BAR Meeting
July 20, 2016

ISSUE: Partial Demolition/Capsulation and Certificate of Appropriateness for Addition and Alterations

LOCATION: 308 Commerce Street

BAR2016-00204 & 2016-00206

Figure 2. CURRENT SUBMISSION, east (side) elevation.

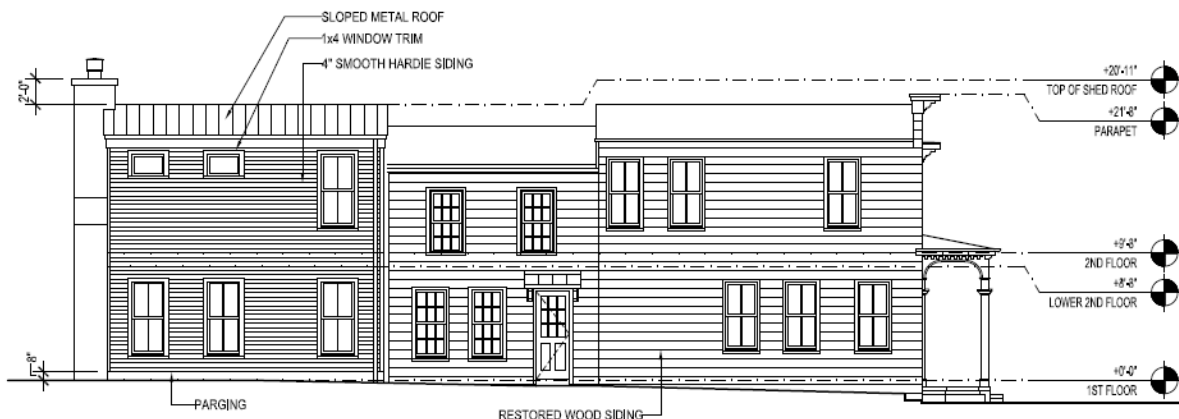
Although this design responded to many of the comments made by the BAR, it introduced a roof form and approach typically not found in the historic district, as flounders historically never were sited in this manner. Although this design was moving in the right direction, staff did not find that it fully satisfied the BAR’s concerns raised at the hearing. A further study (the current submission) followed that staff found to be much more successful in situating the new construction within the context of the existing building (see Figure 2).

This version, the current submission, utilizes a simple shed roof form in line with the height of the main block. As in the previous study, the fenestration was revised to include aligned single windows with a 2/2 light configuration, a reduced parged concrete foundation height and a more

refined and visually lighter chimney. Staff strongly supports the current application finding it to be consistent with the *Design Guidelines* and to satisfy the concerns previously raised by the BAR. The addition is differentiated from the existing house yet appropriate for the context and complementary to the existing building. As a reminder, the east (side) elevation will only be obliquely visible through the yard and the rear (south) elevation will not be visible. The north elevation will be visible, and the use of the shed roof and 2/2 windows here make the new construction coexist harmoniously with the historic building from the street. The use of high-quality composite materials such as fiber cement siding and composite trim will further differentiate the new from the old.

Existing & New
Exterior Elevations

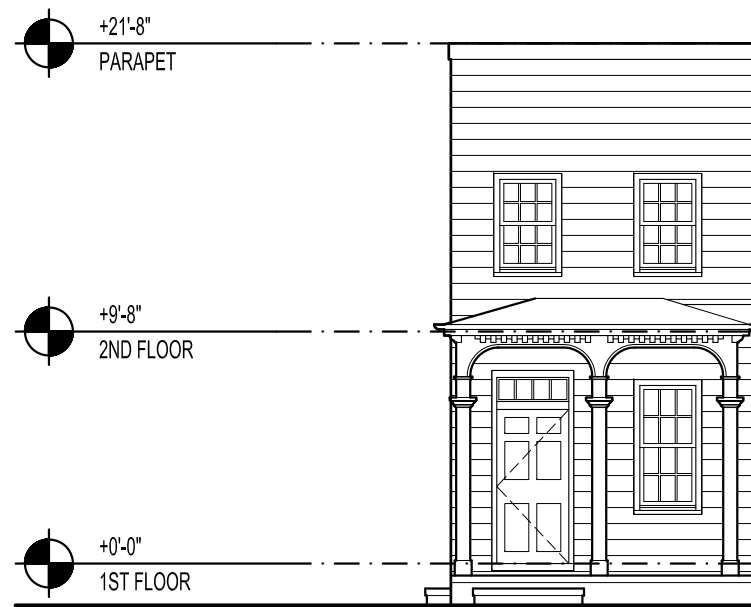
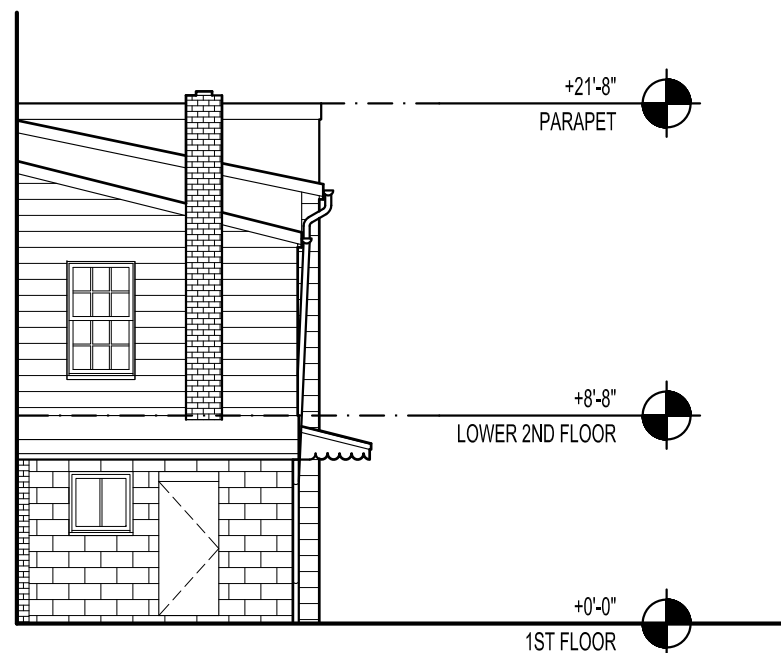
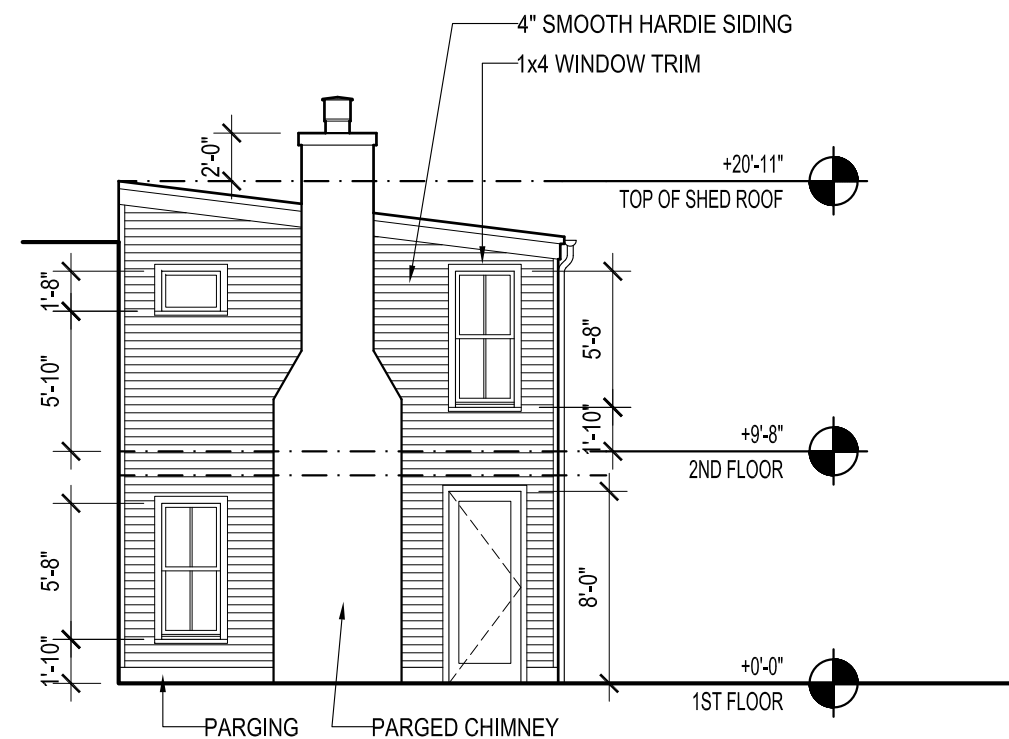
AFTER EXISTING METAL SIDING HAS BEEN REMOVED, OWNER WILL WORK WITH BAR STAFF ON THE DESIGN OF THE CORNICE DETAILS, WINDOW TRIM BRACKETS, ETC.

1. The applicant must work closely in the field with BAR staff on the final design of the cornice, window and door trim of the original building while using documentary evidence in the field prior to submission of the building permit.

1A EXISTING SIDE / EAST ELEVATION
1/8" = 1'-0"

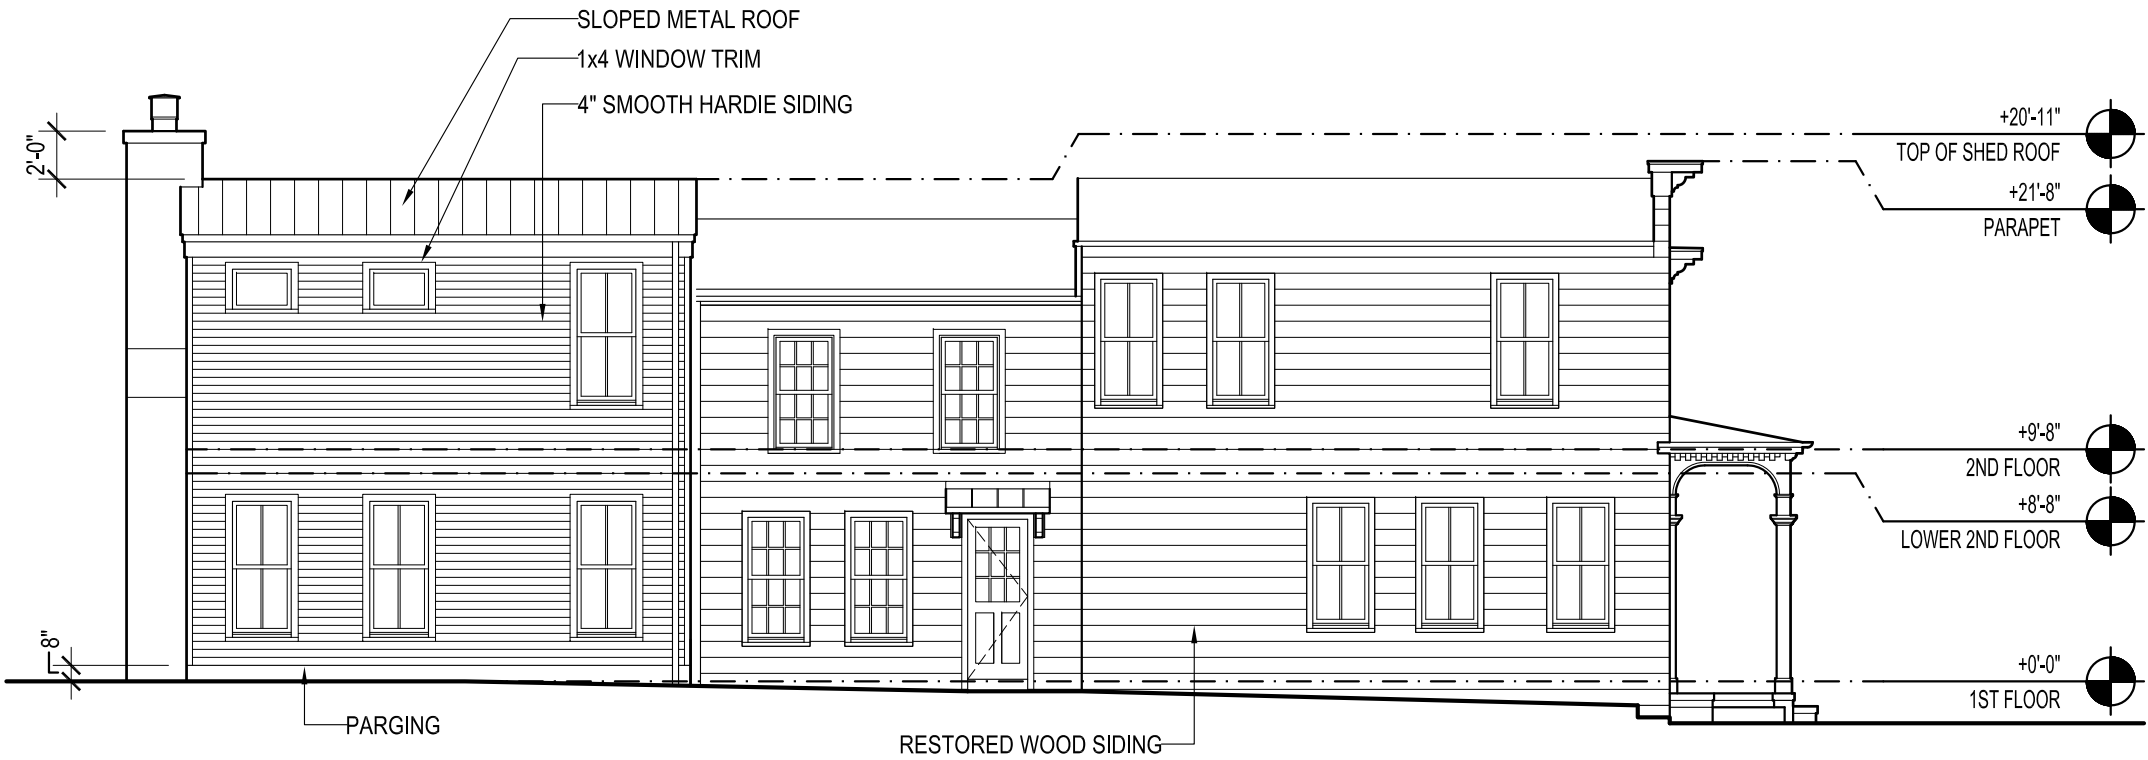
AFTER EXISTING METAL SIDING HAS BEEN REMOVED, OWNER WILL WORK WITH BAR STAFF ON THE DESIGN OF THE CORNICE DETAILS, WINDOW TRIM BRACKETS, ETC.
